County of Santa Clara

STAFF REPORT
Zoning Administration
November 4, 2021

File: PLN20-124

Design Review Approval (Tier 2) and Grading Approval for a New Single-Family Residence

P10.5

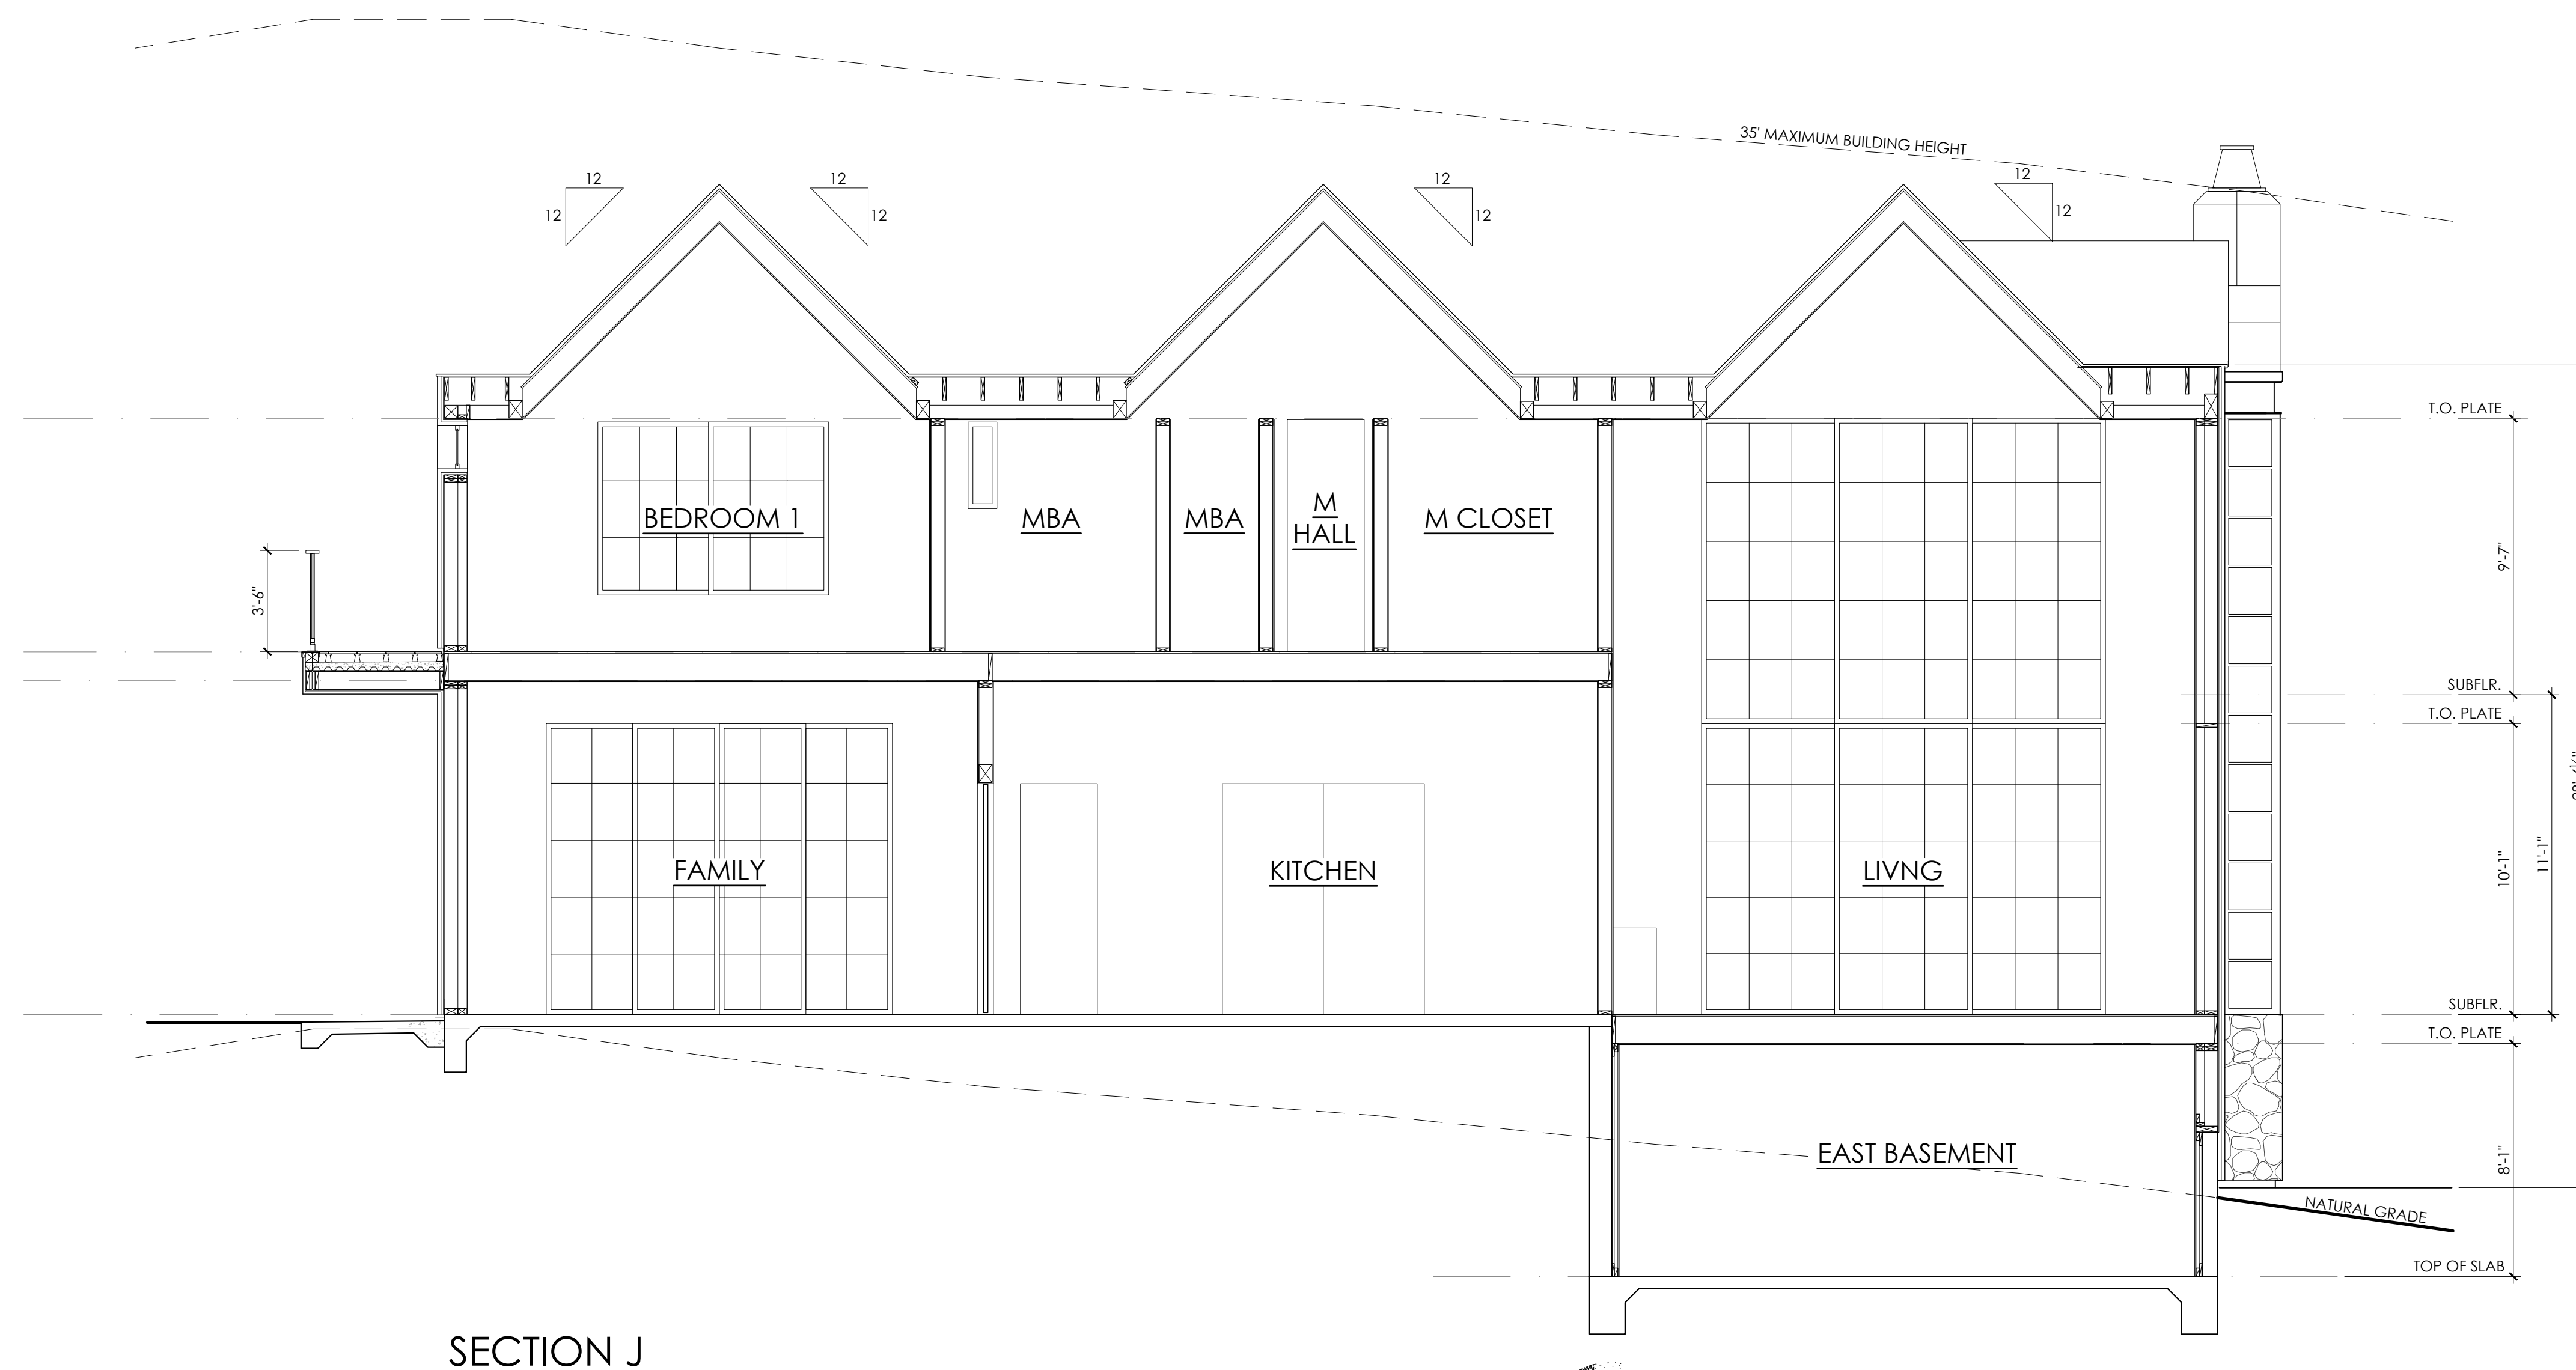
The building form does not incorporate a linear design or a tiered design approach to reduce the building massing and visual bulk, as illustrated in Section E-J (Sheet P 10.3-P10.5, Attachment C). Although portions of the building foundations utilize a stepped approach, massive roof planes are proposed at consistent heights.

Building Setback per Geotechnical Report

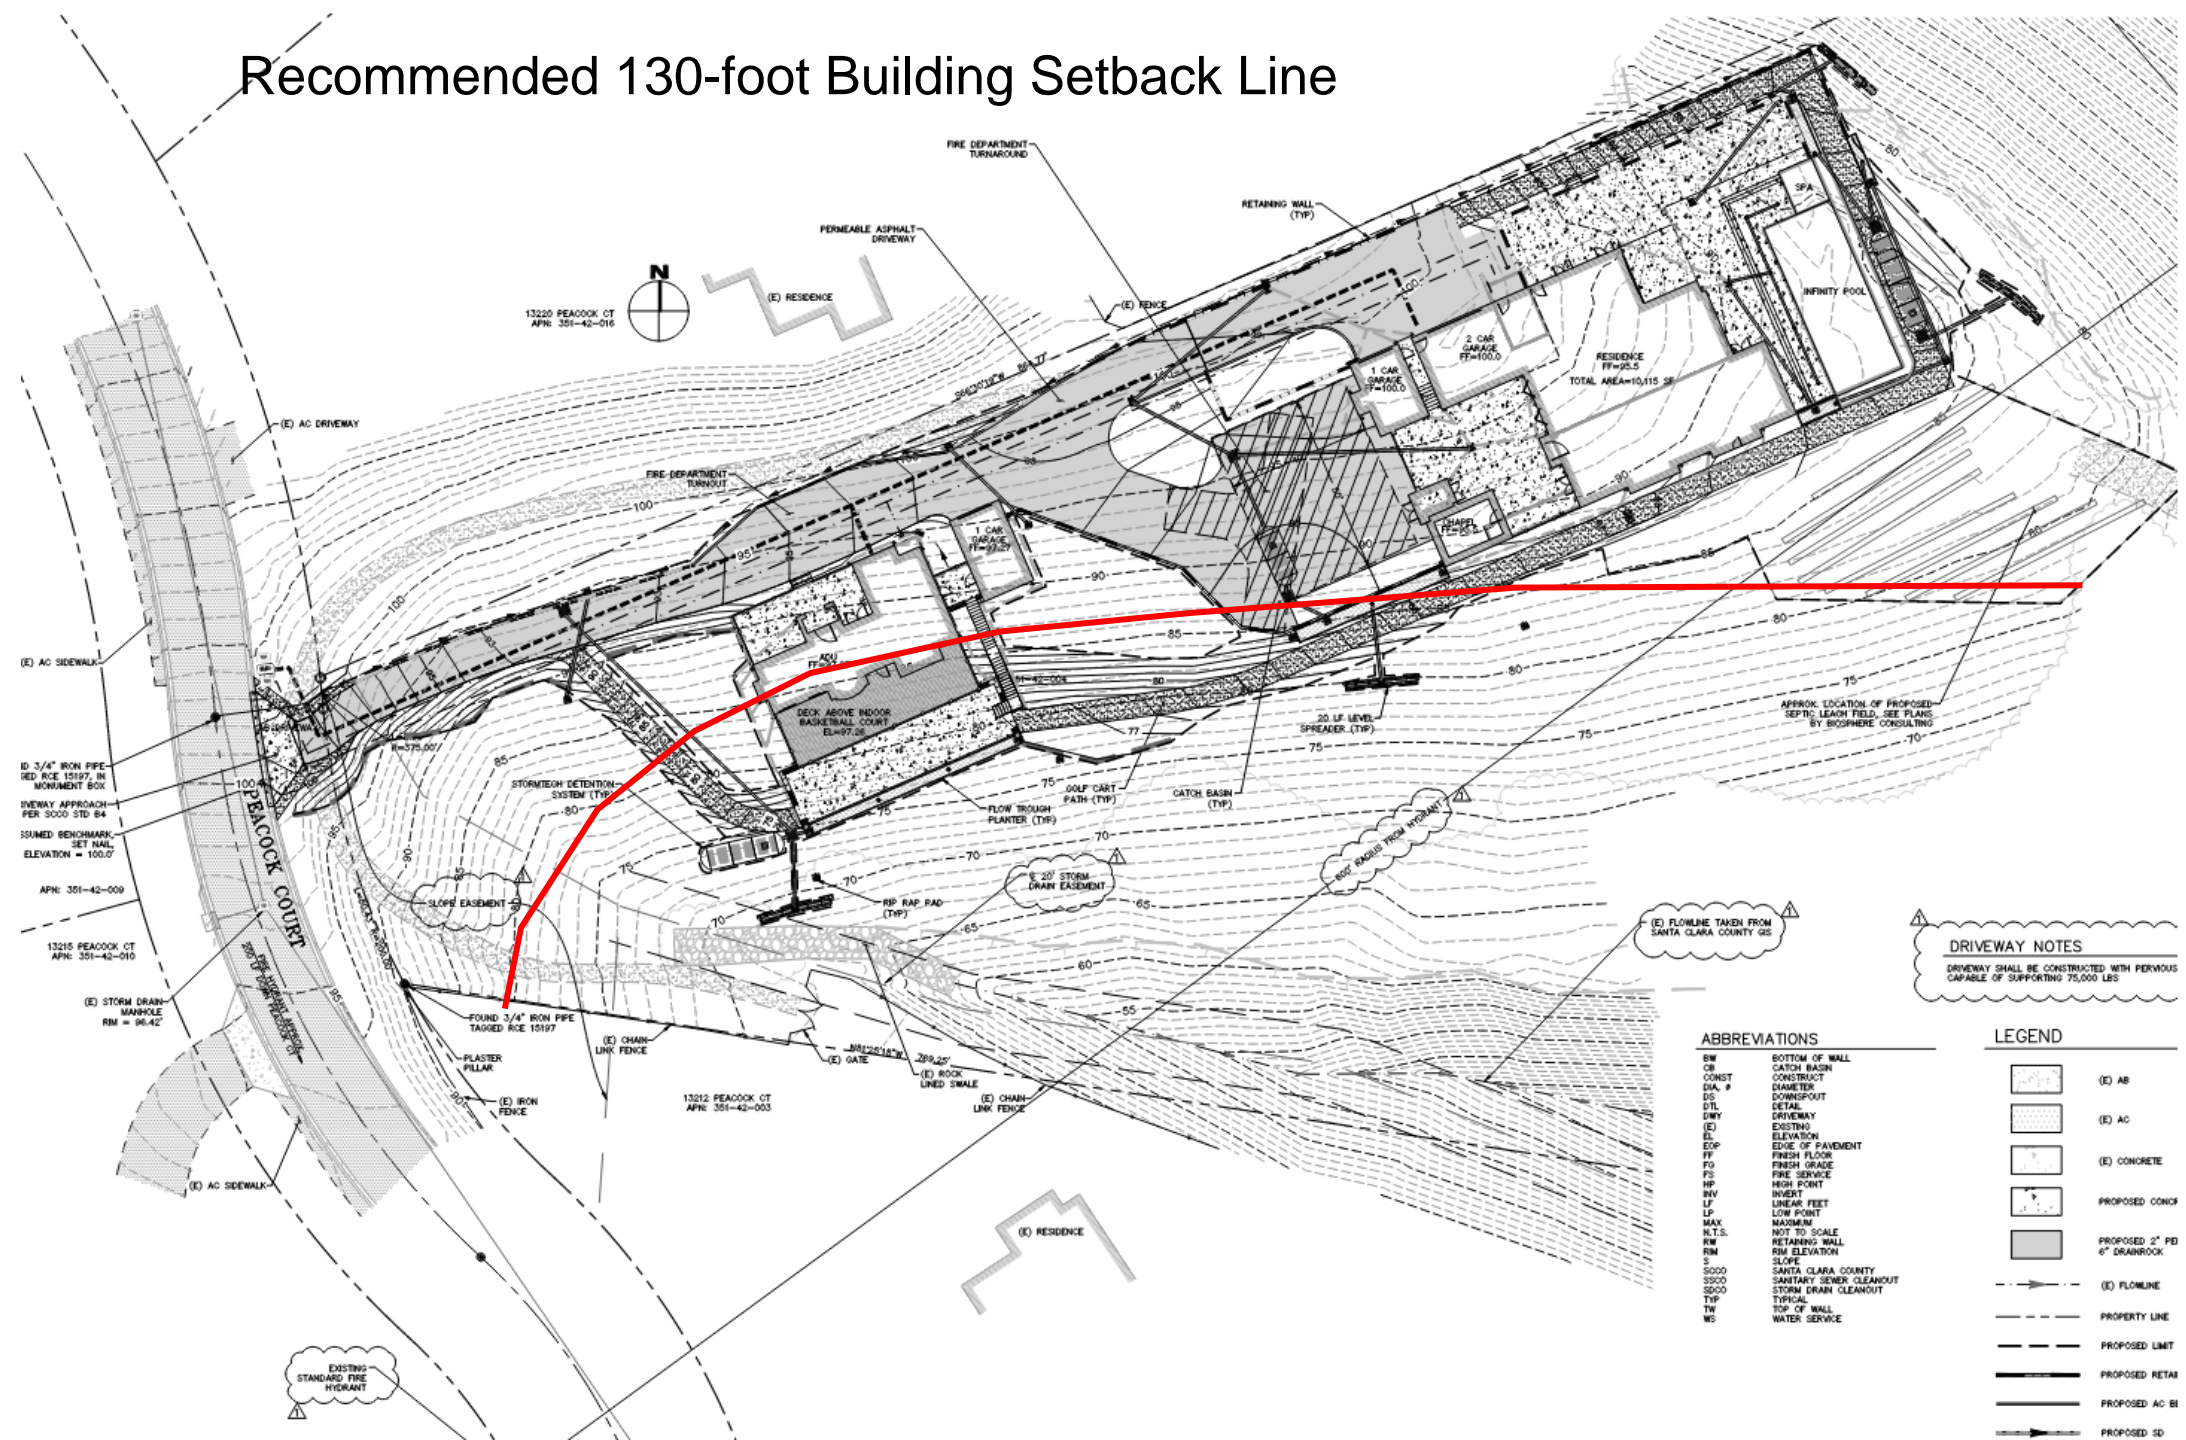
Recommended 130-foot Building Setback Line
